**City Council, Standing Committee and Commission
Conseil, comités permanents et commission**

Report / Agenda: ACS2025-PDB-PS-0020 / 7

Re: Amendments to Supporting Documents 2, 3 and 4

Appendix to Document 2 – Staff-Recommended Changes to Correct Errors in the Final Draft of the Zoning By-law

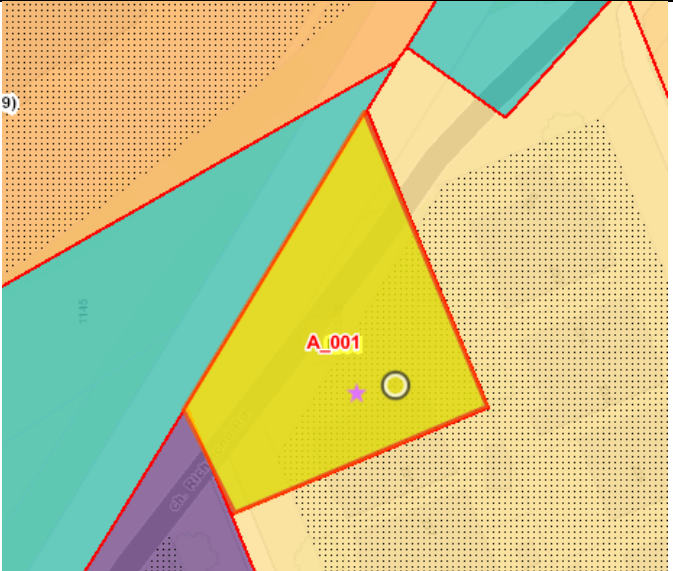
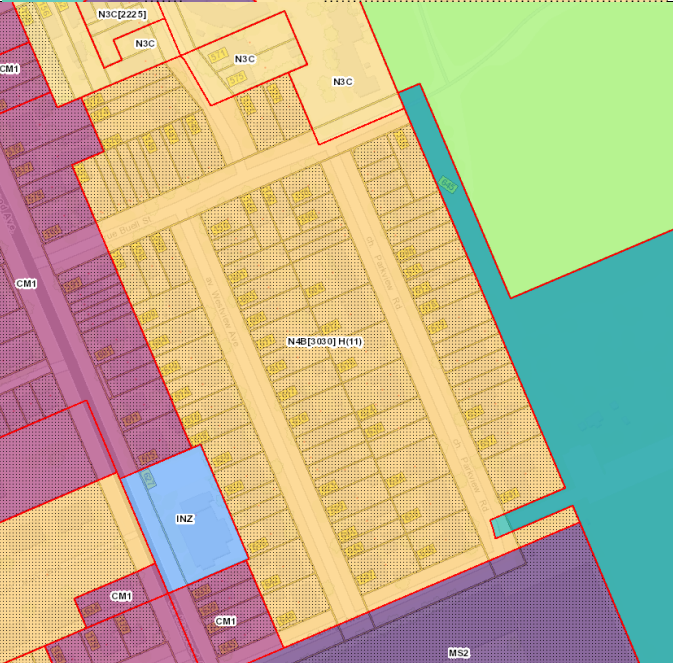
| Part 12 – Special District Zones | | |
|---|---|--|
| 1202(3) | <p>The provisions in the final draft for the ByWard Market Special District Zone include the uses in MD2 – Mixed-Use Downtown Subzone 2 and MD3 – Mixed-Use Downtown Subzone 3 of the current Zoning By-law 2008-250.</p> <p>Some lands in the ByWard Market Special District are currently zoned MD – Mixed-Use Downtown Zone which permits more uses than the MD2 and MD3 subzones in the</p> | <p>(3) One or more of the following uses must occupy 100 per cent of that part of the ground floor fronting on a street, excluding lobby area, mechanical room and access to other floors, for a minimum depth of 3 metres:</p> <ul style="list-style-type: none"> • artist studio • bank • broadcasting and production studio • community centre • government service centre • hotel |

| | <p>current Zoning By-law 2008-250. These uses, shown in bold font, have been added to the list of conditional uses in subsection (3) of the provisions for the SDB – ByWard Market Special District Zone to reflect the uses that are currently permitted.</p> | <ul style="list-style-type: none"> • indoor entertainment facility • instructional facility • library • medical facility • micro-distribution facility • museum • nightclub • payday loan establishment • personal service business • place of assembly • recreation and athletic facility • restaurant • retail store • theatre |

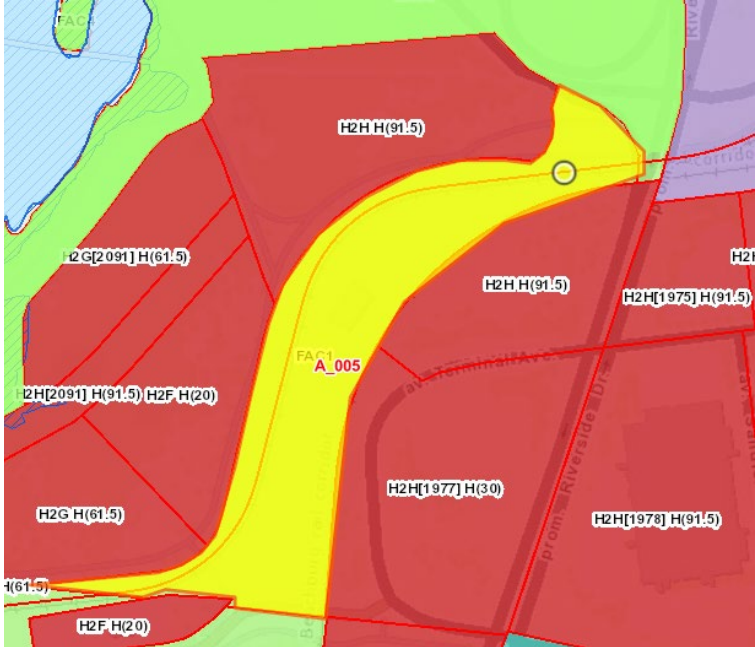
| Part 15 - Exceptions | | |
|-----------------------------|--|--|
| XX19 | Modifications are proposed to improve clarity. | <p>Modify the text of the exception as follows:</p> <p>(3) Prohibited uses: The following land uses are prohibited within Area X the buffer area shown on Schedule XX1:</p> <ul style="list-style-type: none"> • day care • dwelling unit • place of worship • school • an outdoor amenity area associated with a day care, school, dwelling unit, place of worship, or school |

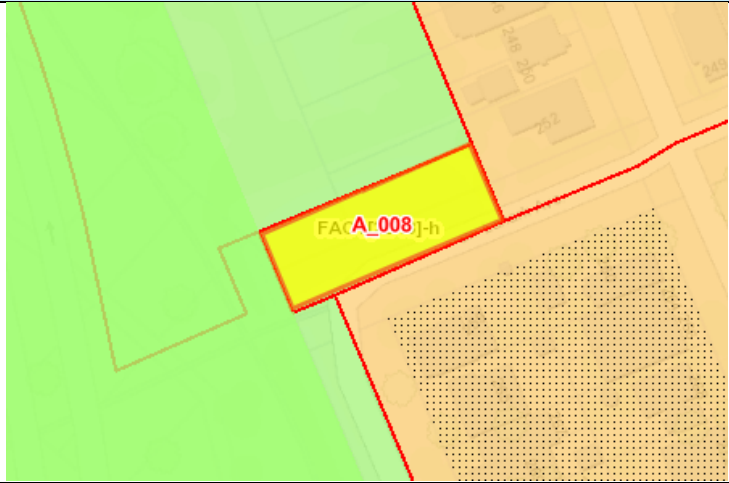
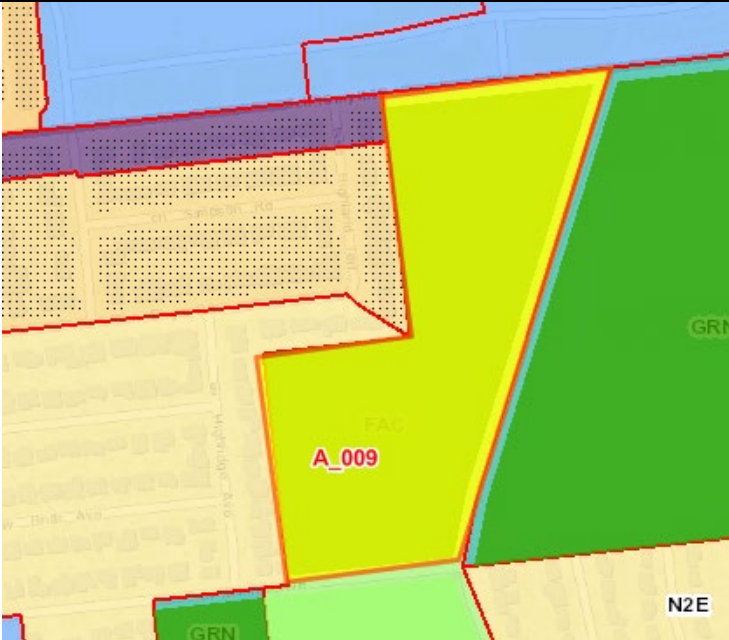
| Part 16 - Schedules | | |
|----------------------------|---|--|
| 508 | Schedule 508 illustrates a maximum building height of 11 metres for a portion of 2179 Elmira Drive where the Pinecrest and Queensview Stations Secondary Plan permits a maximum building height of up to 4 storeys. The | Change the maximum building height of 11 metres illustrated for a portion of 2179 Elmira Drive to 15 metres. |

| | maximum building height will be updated to 15 metres to reflect the Secondary Plan. | |

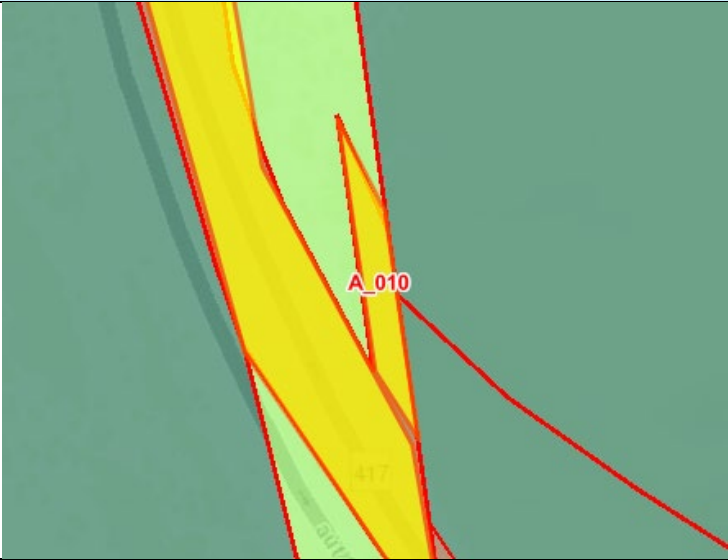
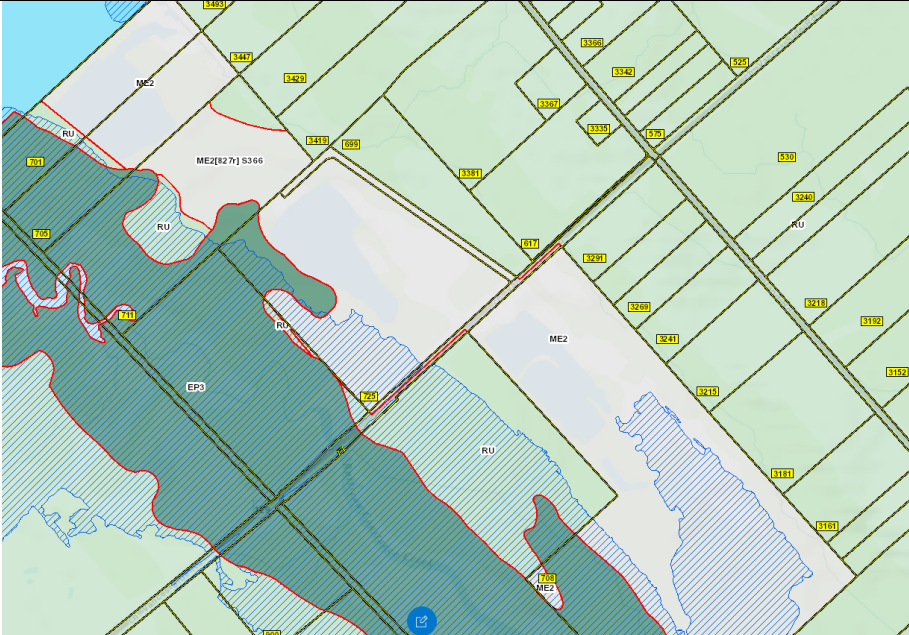
| A1 | Schedule A1 does not include the Tewin lands, whereas Official Plan Schedules B7 and C17 do include the Tewin lands as part of the suburban transect. | Include the Tewin lands in Schedule A1 of the Zoning By-law to render it consistent with Official Plan Schedules B7 and C17. |

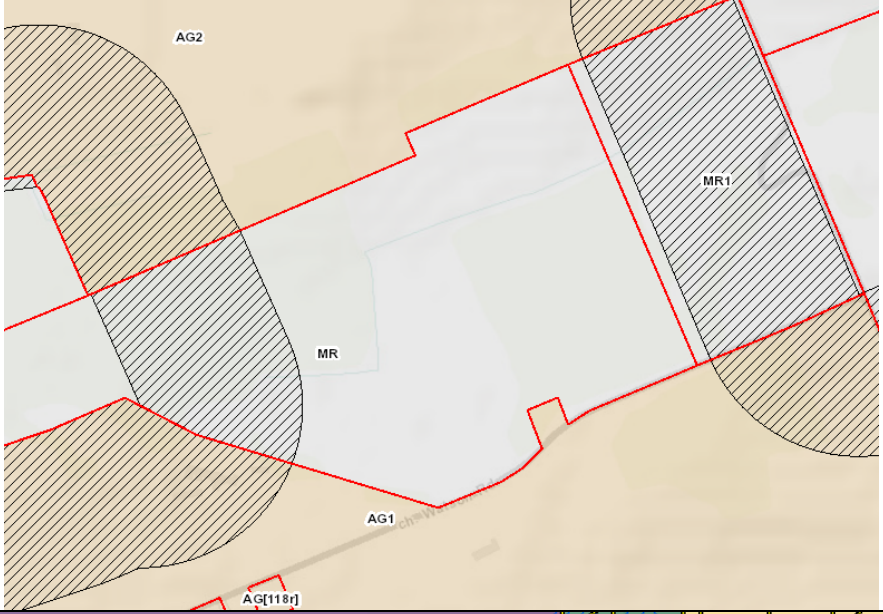
| Corrections (A Code) | | | | |
|----------------------|--------------------------|--------------------------------|--|--|
| A_003 | 6011 Longleaf Drive | Change zoning to GRN. | This property was zoned FAC in error, the zoning should be GRN to reflect the Park sub-designation in the Official Plan. |  |

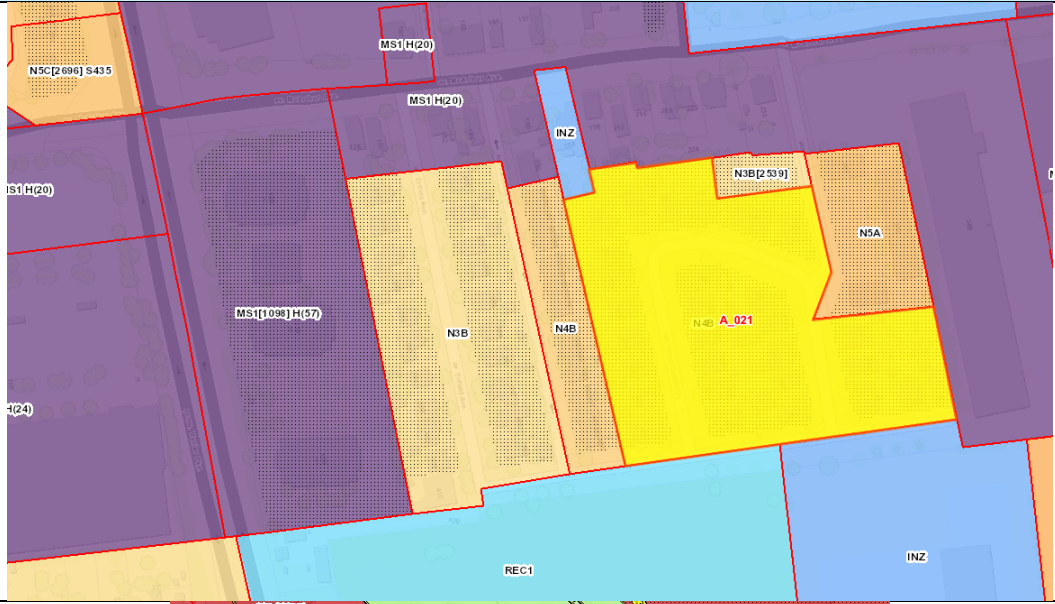
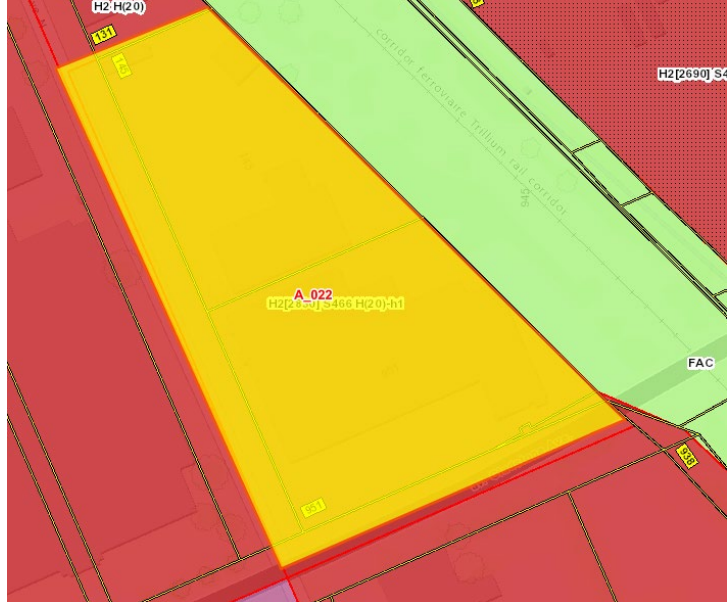
| Corrections (A Code) | | | | |
|----------------------|-------------------------------------|--------------------------------|--|--|
| A_008 | Part of 529 Richmond Road | Change zoning to FAC. | These lands were zoned FAC1 in error, the zoning should be FAC. |  |
| A_009 | 495 Billings Avenue, 550 Smyth Road | Change zoning to GRN. | This property was zoned FAC in error, the zoning should be GRN to reflect the Park sub-designation in the Official Plan. |  |

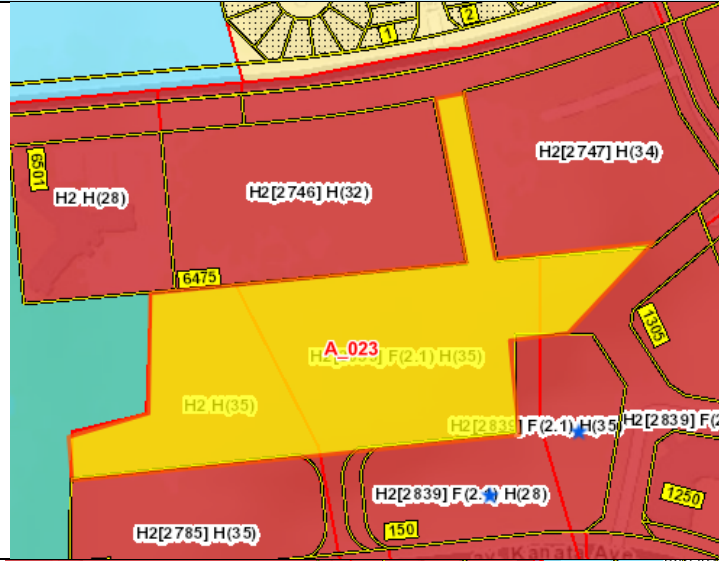
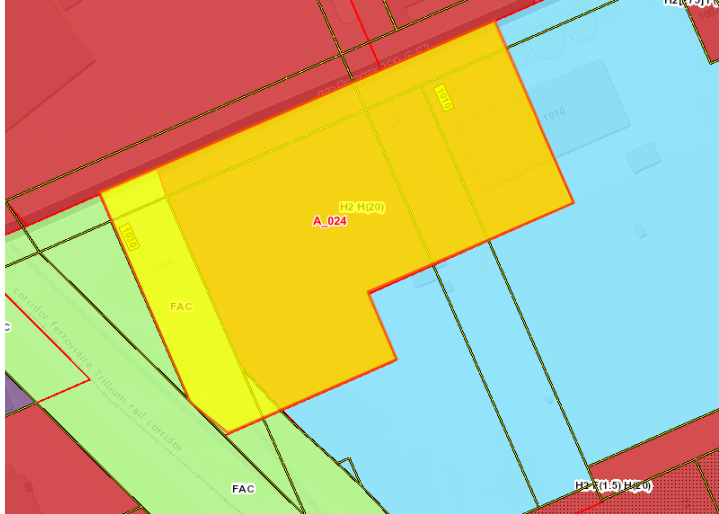
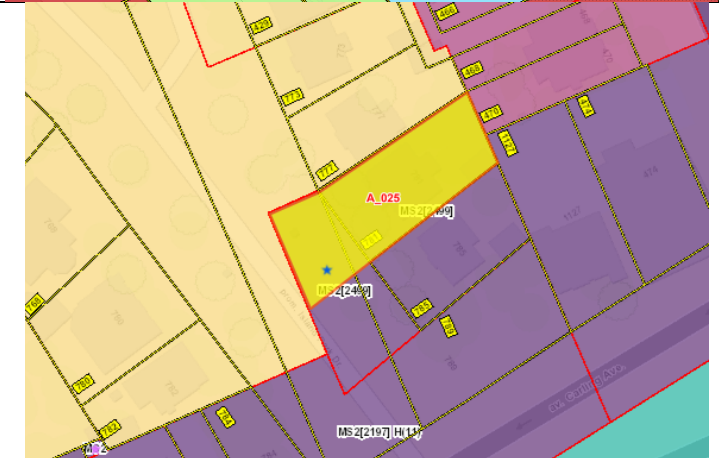
| Corrections (A Code) | | | | |
|----------------------|--|---|---|--|
| A_010 | Near 2965 Walkley Road | Change zoning to FAC3. | These lands were zoned GBR in error, the zoning should be FAC3. |  |
| A_011 | North and south of Vances Side Road, and east of Greenland Road. | Apply the Mineral Aggregate Separation Overlay to ME and MR zones that are outside of the Official Plan Mineral Aggregate Overlay | The Mineral Aggregate Separation Overlay replaces Section 67 in the current Zoning By-law and is based on a buffer from the Mineral Aggregate Overlays in the Official Plan. The current in Zoning By-law 2008-250 Section 67 is measured from ME or MR zones, so this change maintains the existing separation distance. There are three areas where ME or MR zones exist outside of the Official Plan Overlays where staff propose to apply the Mineral Aggregate Separation Overlay. |  |

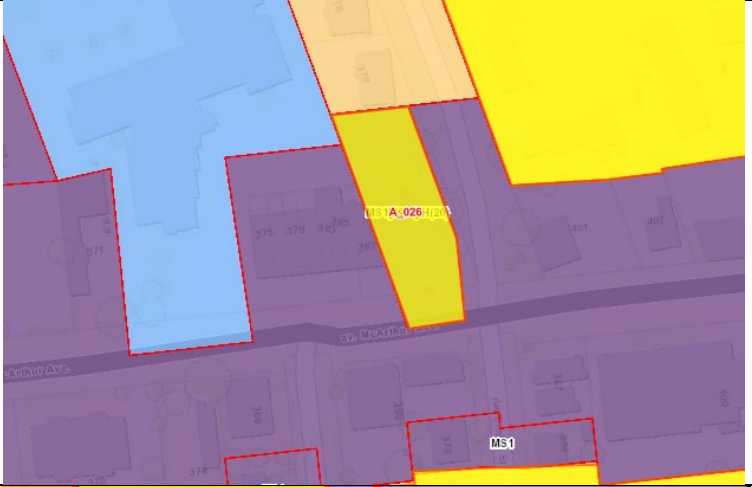
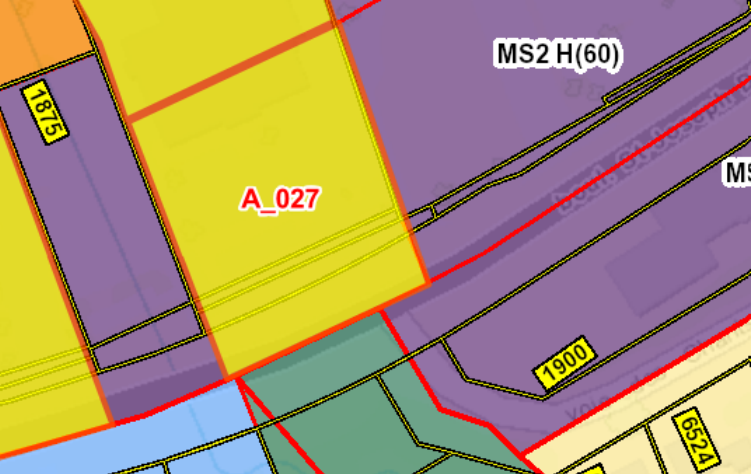
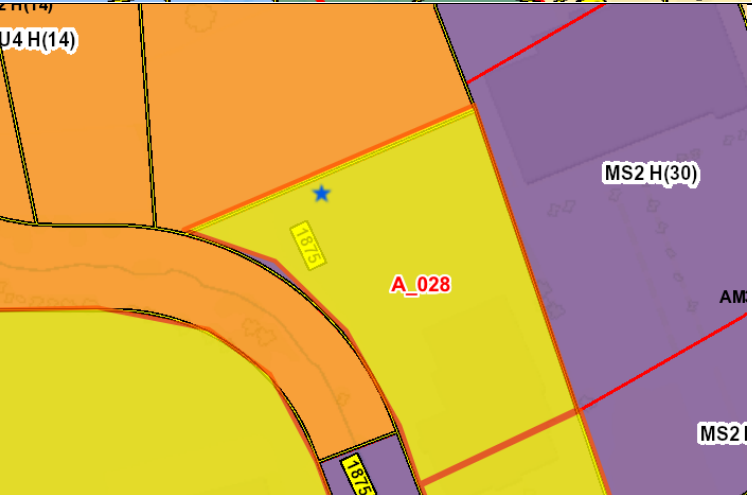
| Corrections (A Code) | | | | |
|----------------------|---|---|--|--|
| A_012 | Area north and south of Rideau Road located to the south of the Airport and Findlay Creek | Apply the Mineral Aggregate Separation Overlay to ME and MR zones that are outside of the Official Plan Mineral Aggregate Overlay | The Mineral Aggregate Separation Overlay replaces Section 67 in the current Zoning By-law and is based on a buffer from the Mineral Aggregate Overlays in the Official Plan. The current Zoning By-law 2008-250 Section 67 is measured from ME or MR zones, so this change maintains the existing separation distance. There are three areas where ME or MR zones exist outside of the Official Plan Overlays where staff propose to apply the Mineral Aggregate Separation Overlay. |  |

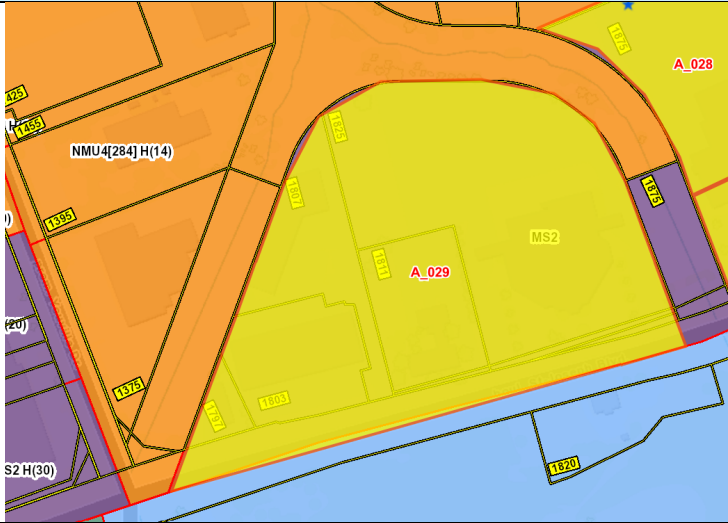
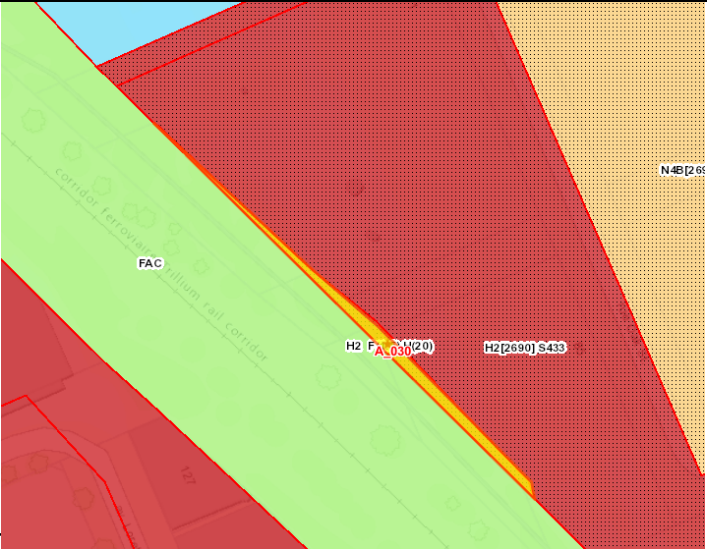
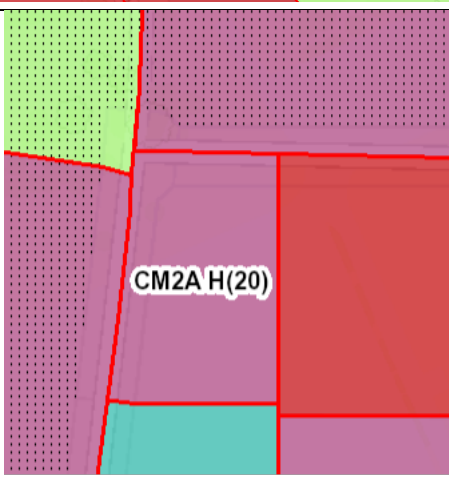
| Corrections (A Code) | | | | |
|----------------------|---------------------------|---|--|--|
| A_013 | 3315 and 3551 Watson Road | Apply the Mineral Aggregate Separation Overlay to ME and MR zones that are outside of the Official Plan Mineral Aggregate Overlay | The Mineral Aggregate Separation Overlay replaces Section 67 in the current Zoning By-law and is based on a buffer from the Mineral Aggregate Overlays in the Official Plan. The currentin Zoning By-law 2008-250 Section 67 is measured from ME or MR zones, so this change maintains the existing separation distance. There are three areas where ME or MR zones exist outside of the Official Plan Overlays where staff propose to apply the Mineral Aggregate Separation Overlay. |  |
| A_014 | 910 March Road | Change zoning from NMU[2962] H(32) to MS2[2962] H(32) | This property is located on a Mainstreet Corridor, so MS2 is the appropriate zoning. NMU is intended to be used in the Neighbourhood designation. |  |

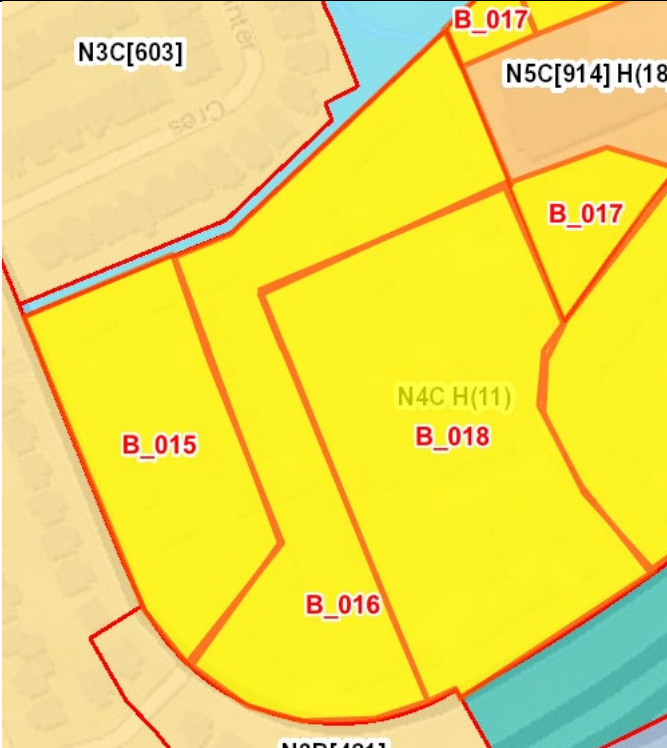
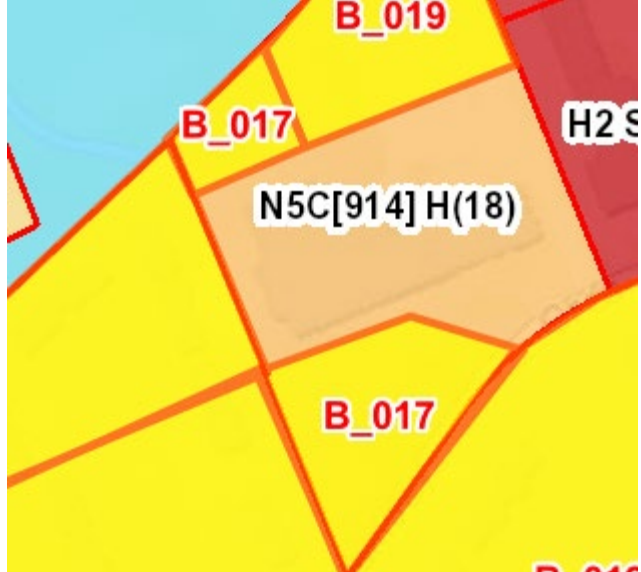
| Change of Intent (B Code) | | | | |
|------------------------------------|-----------------------------|---|--|--|
| B_001 | 627 Kirkwood Avenue | Change zoning from INZ to CM1 to reflect Official Plan designation. | The property is designated Minor Corridor in the Official Plan. The proposed Minor Corridor 1 zone accurately applies that Official Plan designation. |  |
| B_002 | 2110 Carp Road | Change zoning from RC[876r] to DR[876r] | This is a city-owned parcel that is partially occupied by a park and ride. Unless there is an active Zoning By-law Amendment, application or for lands subject to the Future Neighbourhoods Overlay, rural zones are being converted to urban zones. This parcel has a split Neighbourhood and Industrial and Logistics designation, which may require site-specific zoning to accommodate sensitive uses in proximity to industrial uses if it were to develop in the future. |  |
